Subject: DEVELOPMENT CONSENT ORDER APPLICATION REFERENCE NUMBER TR010035 A585

A585 WINDY HARBOUR TO SKIPPOOL IMPROVEMENT SCHEME PLANNING ACT 2008 DEVELOPMENT CONSENT ORDER APPLICATION REFERENCE NUMBER TR010035

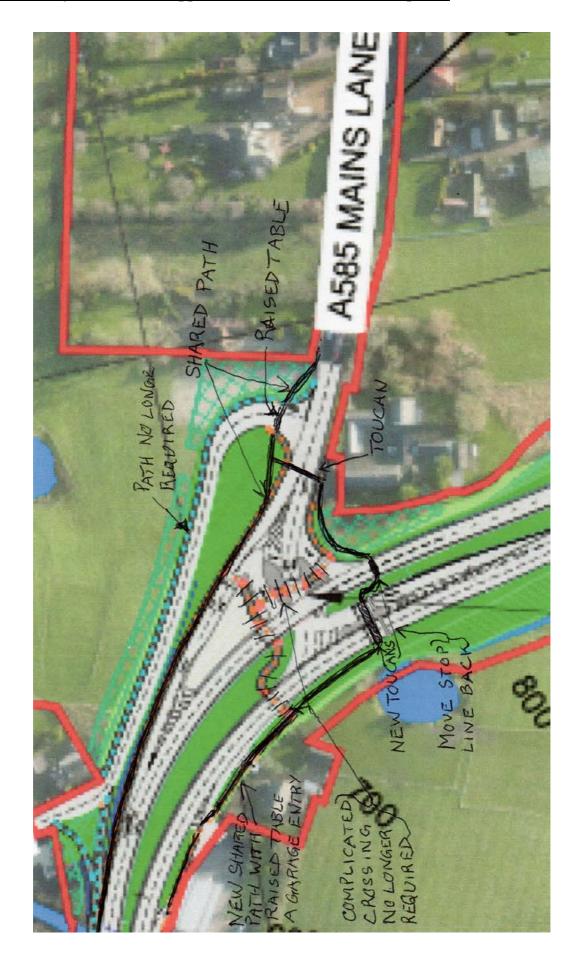
The entry just after the bus stop. It is not clear to me what this entry is for. At present it goes nowhere but presumably there is some development planned on the field. The design of this entry is totally unacceptable. It is contrary to all guidance for crossing a cycle route beside a main road and is very dangerous. Cyclists are expected to stop and look back 180 degrees and ensure that no vehicle is about to turn in at high speed before they cross. When there is heavy traffic this requires them to determine whether any of four or five approaching vehicles is going to swing in without signalling. A totally impossible task.

The next junction has the same problem but it also has a problem for west bound cyclists. The view for them of traffic on the minor road approaching this junction is very limited. And drivers on this minor road approaching the junction will be looking for traffic on the main road approaching from their

I am also puzzled by the item marked as **Keyworker Homes** on the downloaded plan. Is this to have another entry across the shared cycle path?

At present they can go right round the Skippool roundabout. With the new traffic light junction will they be doing a "U" turn which will put them in conflict with pedestrians crossing the eastbound carriageway? The alternative is to go right on to the Norcross Roundabout or turn up Breck road and reverse into a side road to turn round.

The best solution would be for both these entries to be replaced by a service road from Old Mains Lane but this would be expensive as it would require a bridge over Main Dyke. At the very least the two entries should be combined into the first entry and land provided to bend the cycle track in with a priority crossing set back from the main road. This should be a condition of any development of this site. Or possibly all these places could be served by a service road from Skippool Road again as a condition of any development. These sites shouldn't access the strategic road directly.
